CHARLTON
RIVERSIDE
P H A S E O N E

LANDSCAPE AND BIODIVERSITY DAS ADDENDUM

CHARLTON RIVERSIDE PHASE 1

DESIGN & ACCESS STATEMENT ADDENDUM

PLOT A RELOCATE CAR PARK ENTRANCE

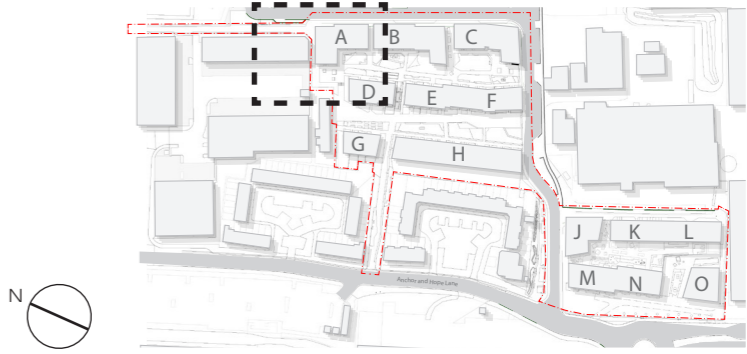
The layout of Building A was amended to include a basement carpark entrance. This has resulted in changes to the landscape as follows:

- 1 New planters to the basement carpark entrance
- 2 The road on the eastern boundary has been widened to accommodate two-way traffic into the basement carpark in building A.
- 3 A new planter replaces the private amenity terrace on the north western corner of the building. The building slab has been raised locally to accommodate the length of the carpark ramp below.

ACTIVATE STREET FRONTAGE ALONG THE FUTURE EAST WEST LINK

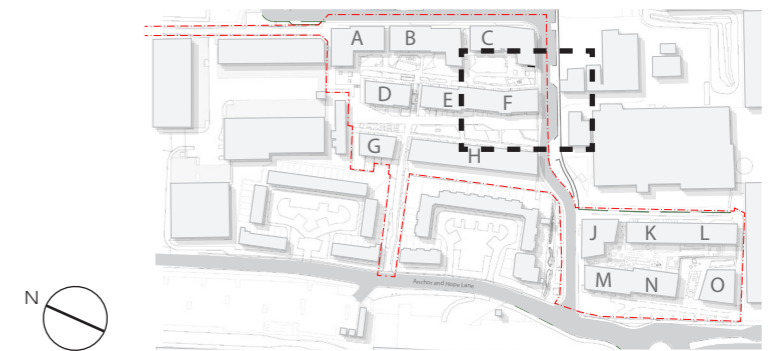
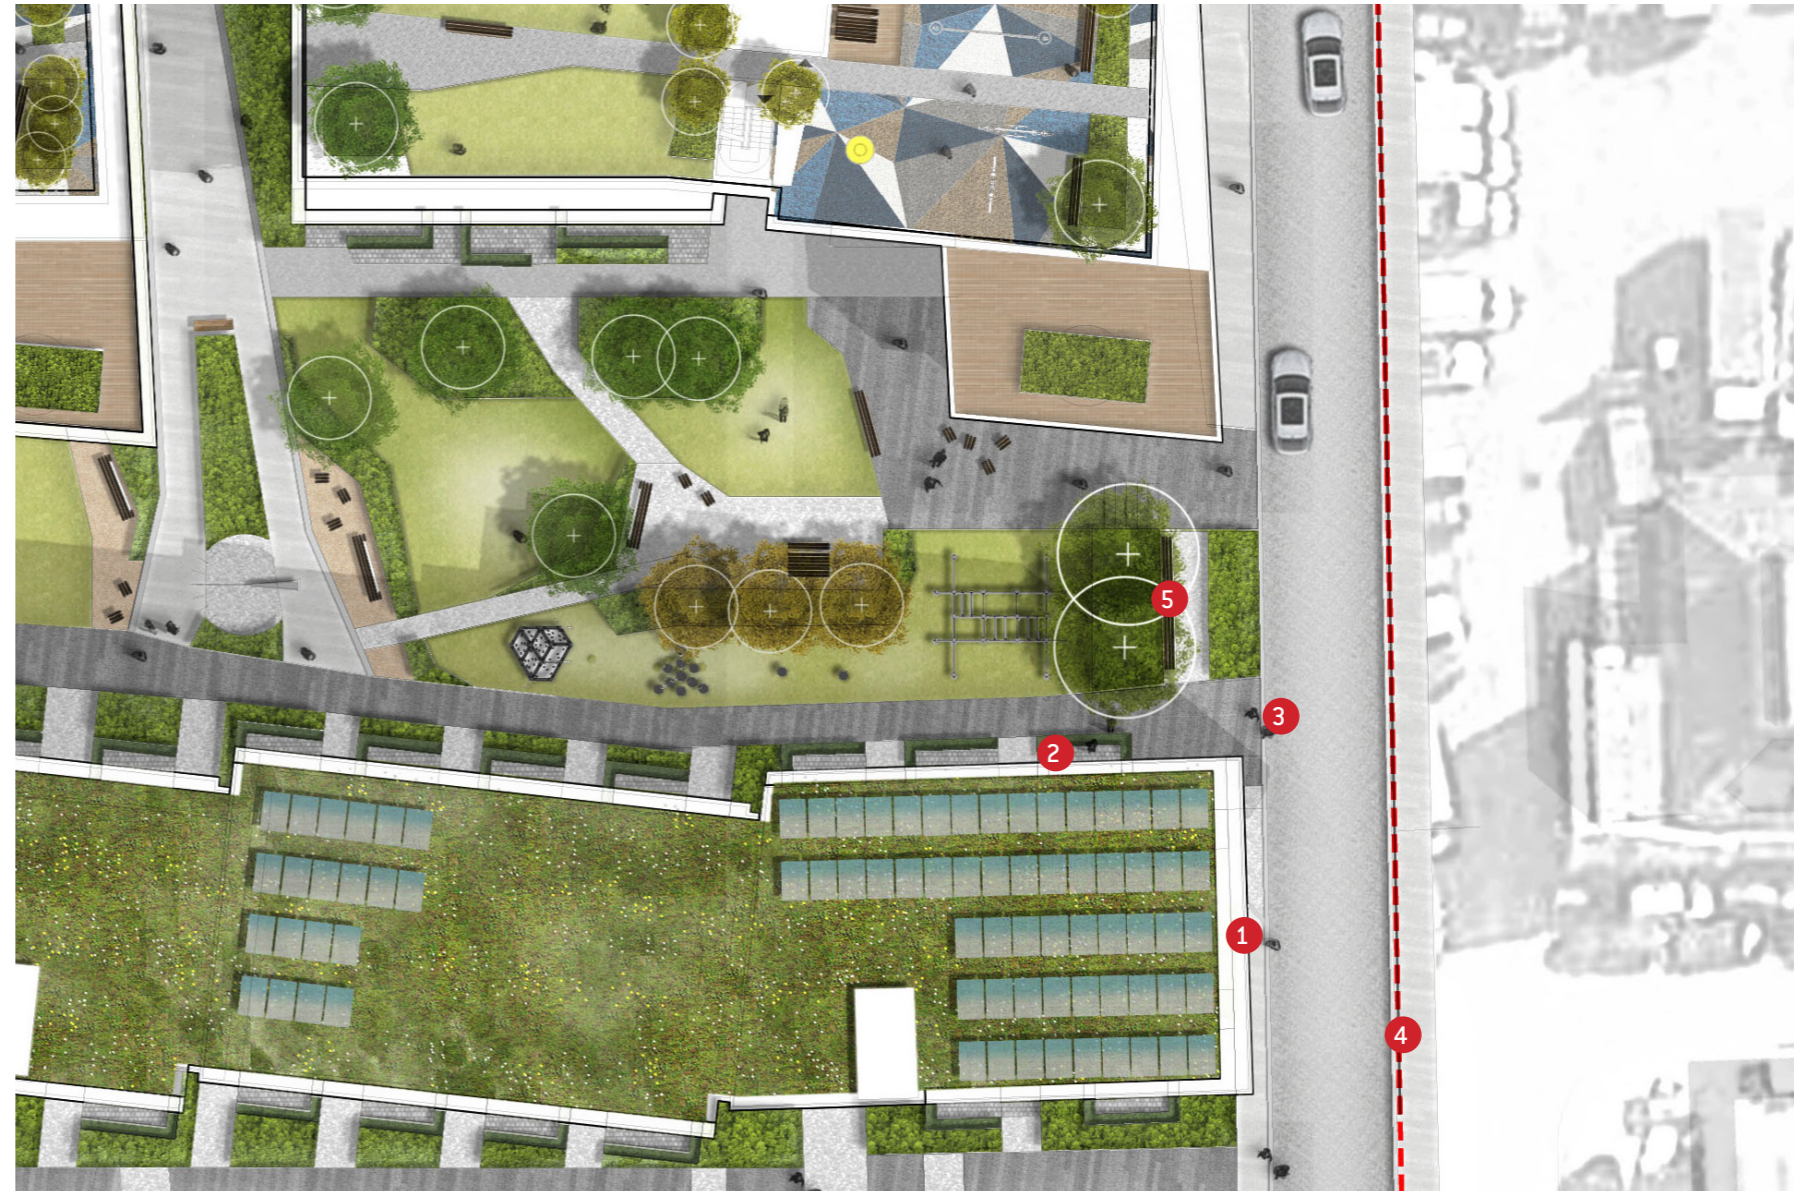
The car park entrance has been relocated from Building F and replaced with apartments to encourage activation along the east-west link.

- 1 The carpark entrance to Building F has been replaced with 3x apartments. Entrances for two of these is directly off the footpath of the east west route to encourage activation of the street frontage. The finished floor levels of the apartments are 'stepped' to work with the road levels.

- 2 3x private amenity spaces have been added to the proposed additional 3x apartments.
- 3 The east west route has been slightly realigned following the removal of the basement carpark entrance

- Levels have been reviewed and revised along this road and now represent a more gradual incline over a longer distance. Refer to drawings ExA_1752_301 & 302

- 4 A vehicle restraint barrier has been added to the southern red line boundary adjacent to the east west route to respond to the level change between existing and proposed levels.

- 5 The seating area in front of the Community Centre space has been set back further from the road to accommodate road realignment and revised levels.

SET BACK CORNER OF BUILDING M

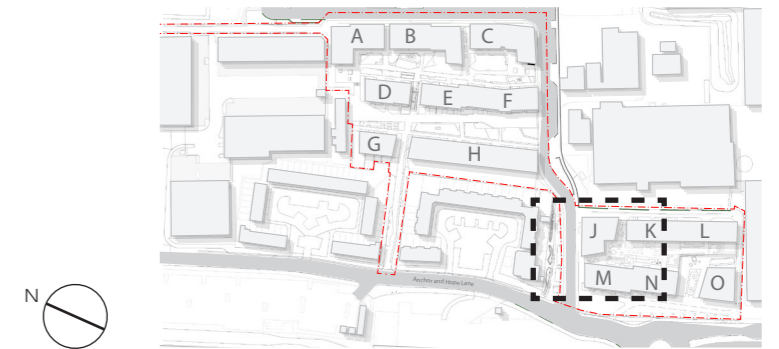
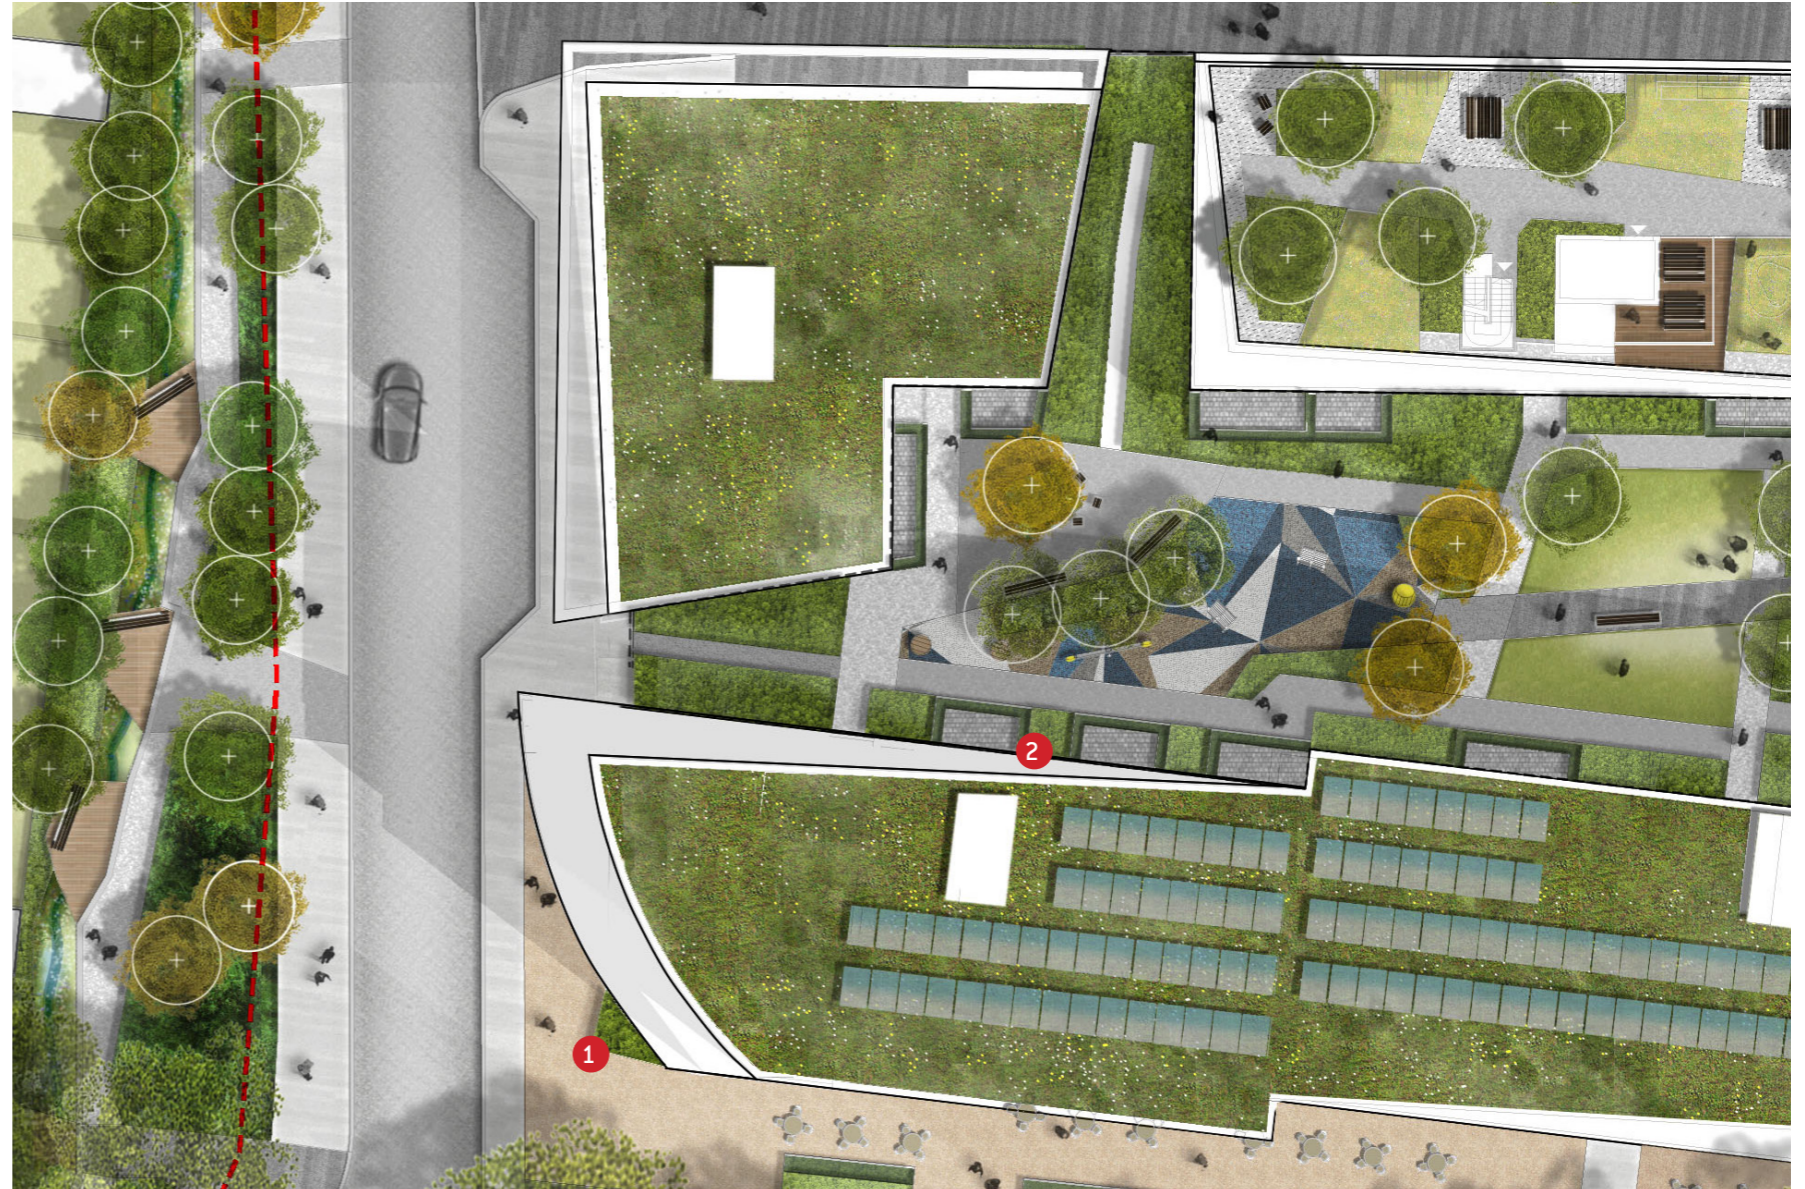
Building M has been set back and curved on the northern side to allow for the roundabout and associated cycle path on the future road plan.

- 1 Amendments to the planting on the northern edge of Building M at ground floor
- 2 Adjustments to 2x of the private amenity spaces at podium level

Following updates to the residential apartment mix; the cycle parking provision requirements have been updated and amended.

Previously 18 cycle spaces were provided on plot A within the public realm. Following updates to the scheme the Draft New London Plan has a minimum requirement for 18 spaces. The updated scheme now shows a provision of 20 spaces within the public realm on Plot A.

Previously 29 cycle spaces were provided on plot B within the public realm. Following updates to the scheme the Draft New London Plan has a minimum requirement of 27 spaces for plot B. The updated scheme shows a provision for 28 spaces within the public realm on Plot B.
